DESIGN <i>KE</i>	DRAWN BY <i>CP</i>	DART AEROSPACE LTD HAWKESBURY, ONTARIO, CANADA	
CHECKED <i>KE</i>	APPROVED <i>[Signature]</i>	DRAWING NO. DEO 9121	REV. A SHEET 1 OF 1
DATE 98.12.11		TITLE END PLATE CHANGE	SCALE NTS
A	98.12.11	NEW ISSUE

## **DART ENGINEERING ORDER**

AMEND DRAWING D2678 REV. B

FIGURE 1

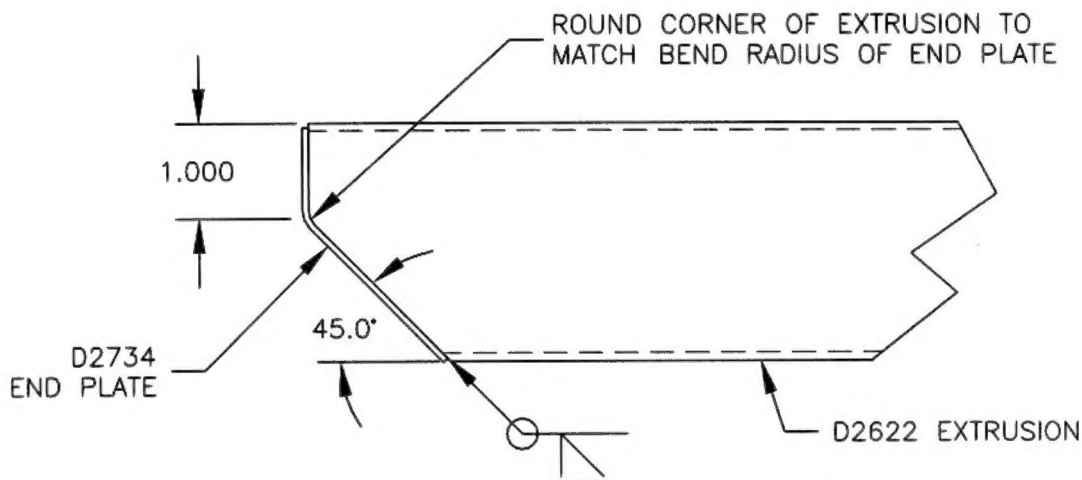
- (2) REPLACE REFERENCE TO D2669-45 ON PAGES 2 AND 4 WITH D2734
- (3) MAINTAIN OVERALL EXTRUSION CUT LENGTH OF 104.45
- (4) CUT AFT END OF D2622 EXTRUSION AS SHOWN BELOW IN FIGURE 1.
- (5) INSTALL D2734 END PLATE AS SHOWN BELOW IN FIGURE 1. WELD PER DART QSI 004.
